Technical product information

Topic	Creaking noise from the upper C post trim panel
Market area	Bentley: worldwide (2WBE)
Brand	Bentley
Transaction No.	2061928/2
Level	EH
Status	Approval
Release date

Creaking noise from the upper C post trim panel

Figure 1

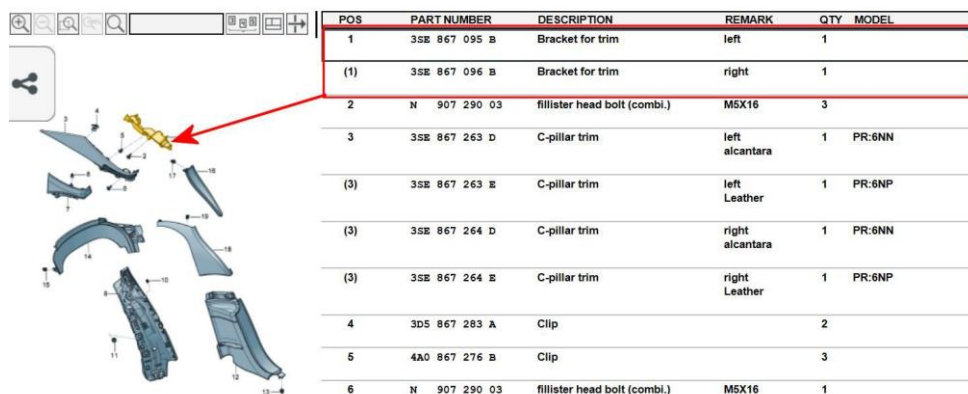
2) Remove the applicable upper C post trim panel – Refer to Rep.Gr 70 to gain access to the Brackets shown in Figure 1

Figure 2

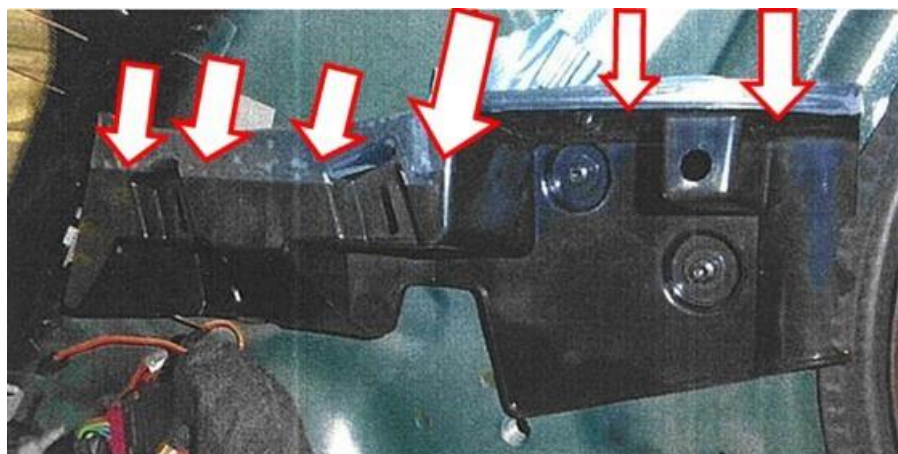
- Referring to Figure 2 - Remove the transparent tape from the upper C post bracket upper edge, making note of the original location points

- 3) Apply anti-squeak tape along the upper C post bracket upper edge in the exact location that the transparent tape was removed from
- 4) Referring to Figure 3 - Ensure that the clips and apertures (highlighted in red boxes) are not blocked by the anti-squeak tape. If they are blocked on initial fixing of the tape, adjust/cut the tape as required to ensure the holes are free
